ADDENDUM NO. 1

ISSUE DATE: April 4, 2018

CRC College Center Expansion

LRCCD BID NO. 17021

SHEET NO:
E3.03

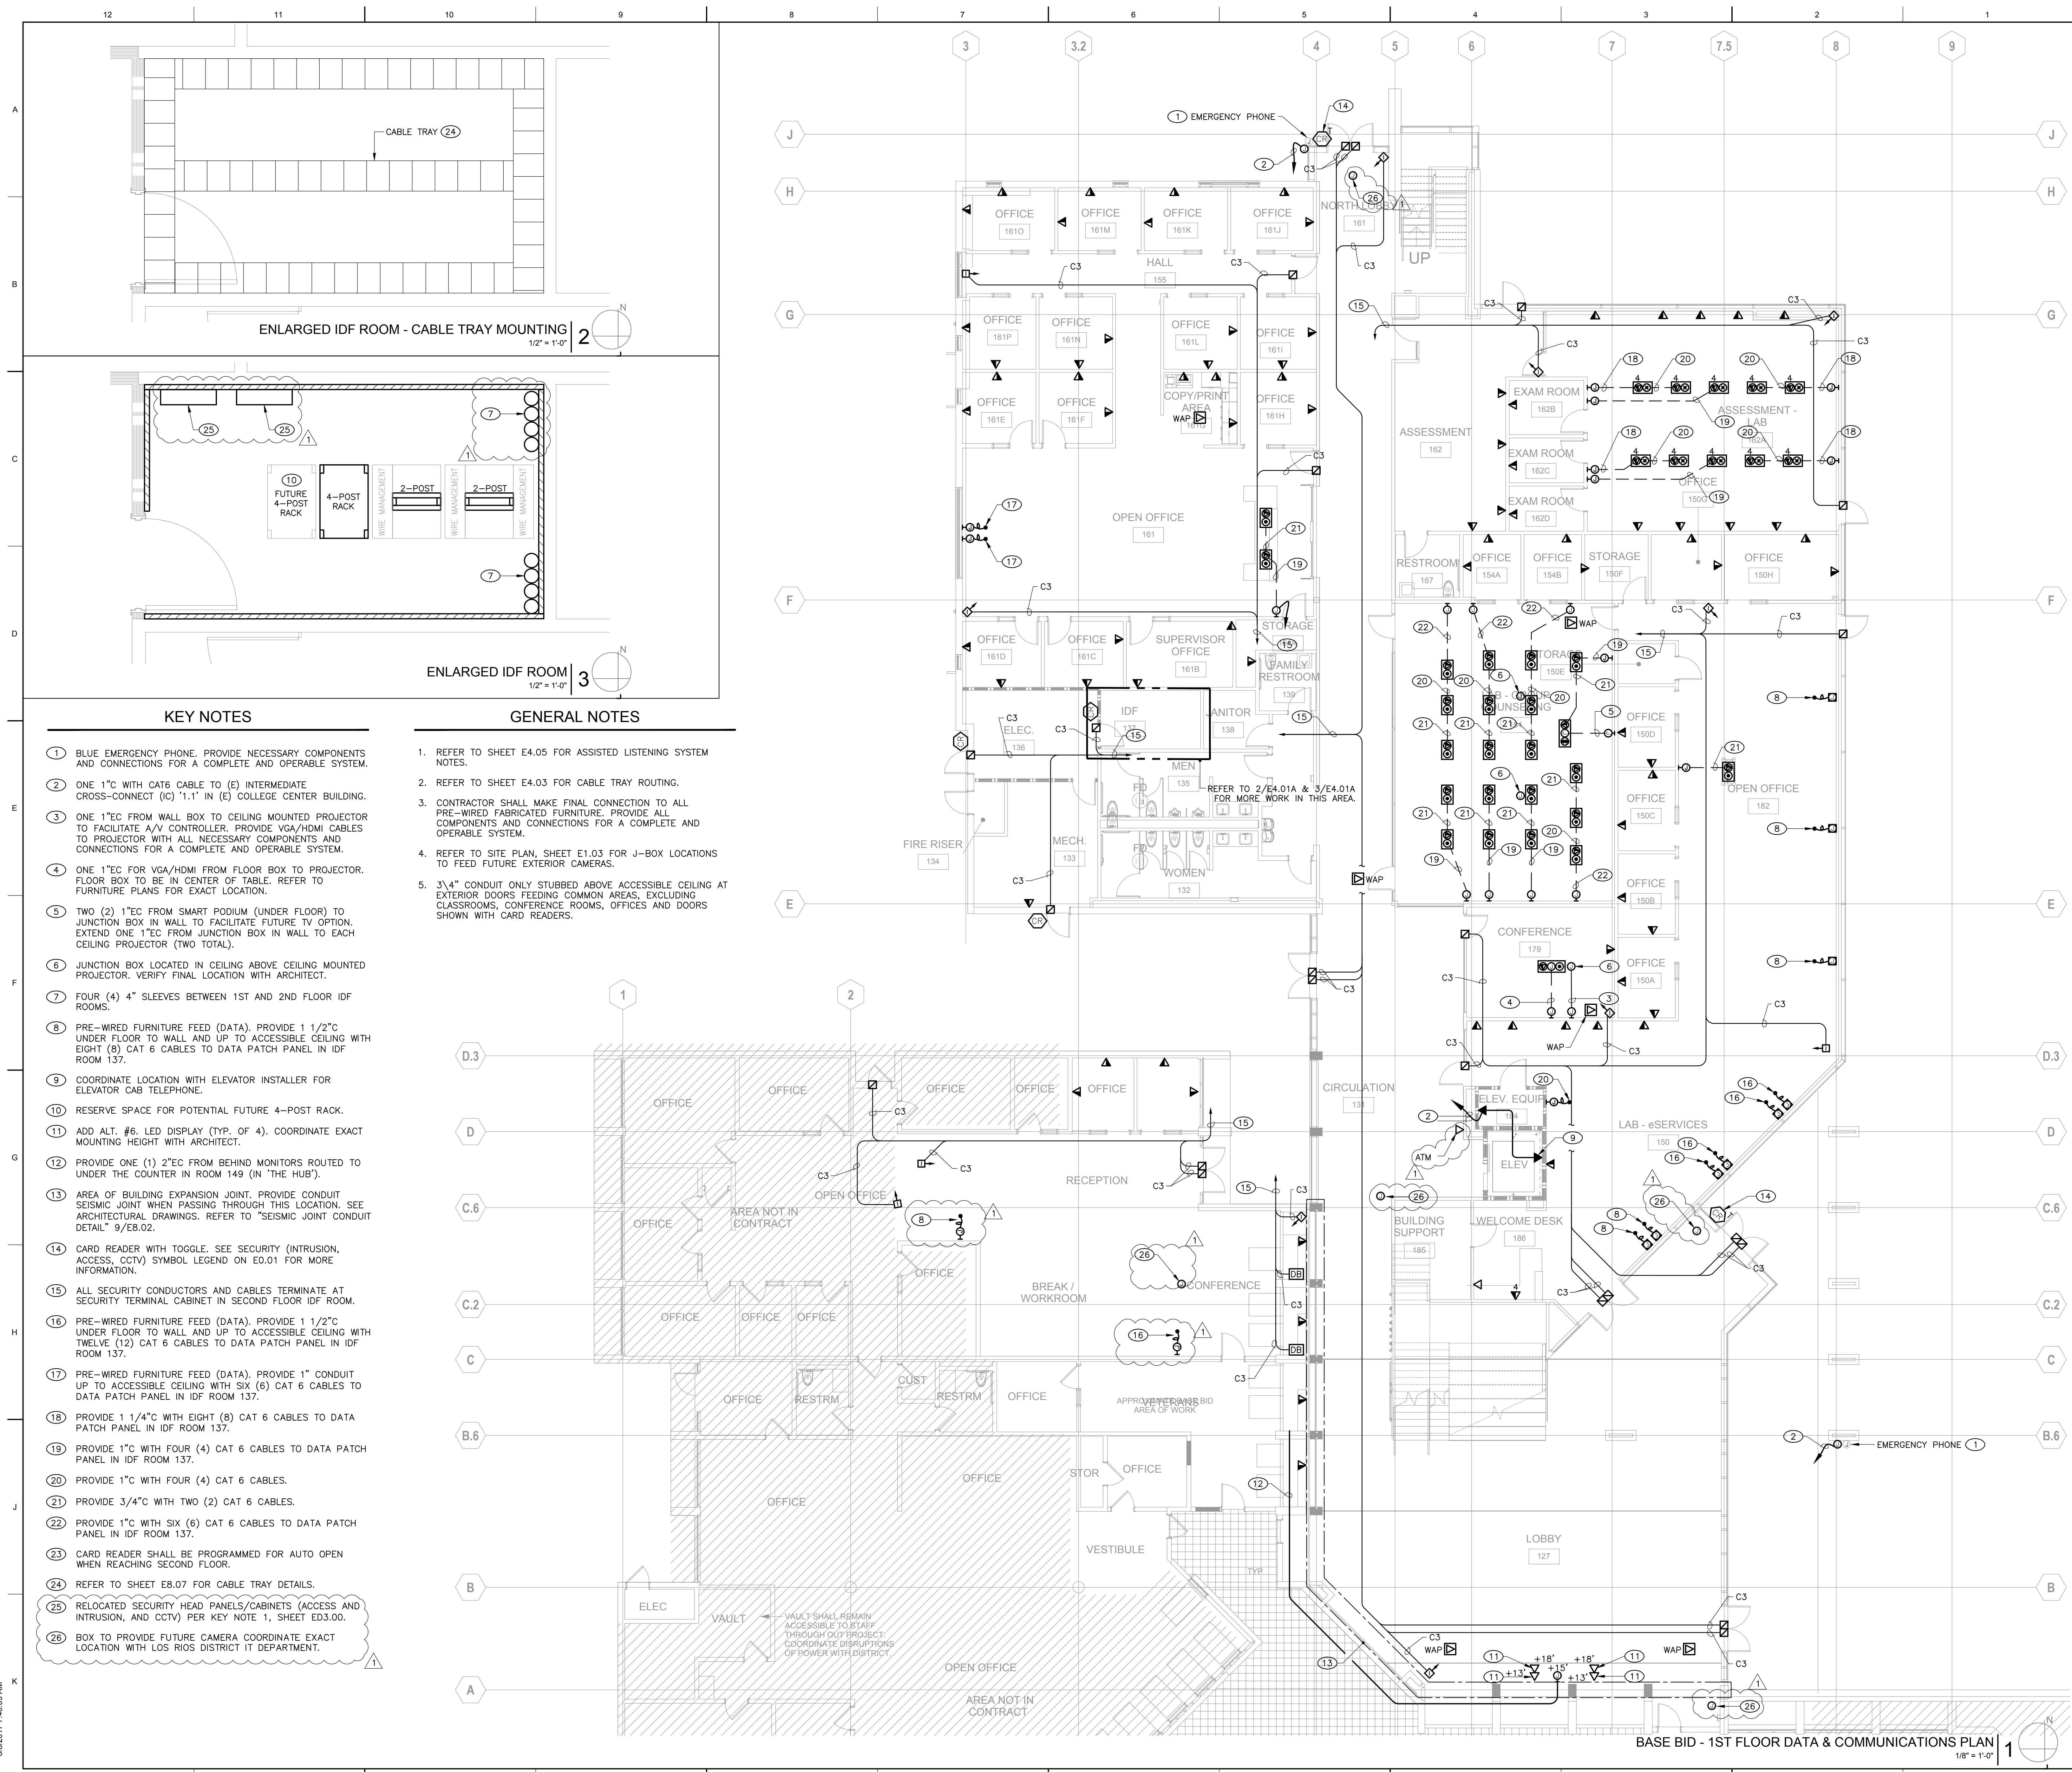
- E3.01B – Revised scope of work
- E3.02 – Added key note 12 for receptacle coordination with D6/A7.11
- E3.03 – Revised key note 2 for AHU's fused disconnect switches and added 2 maintenance receptacles
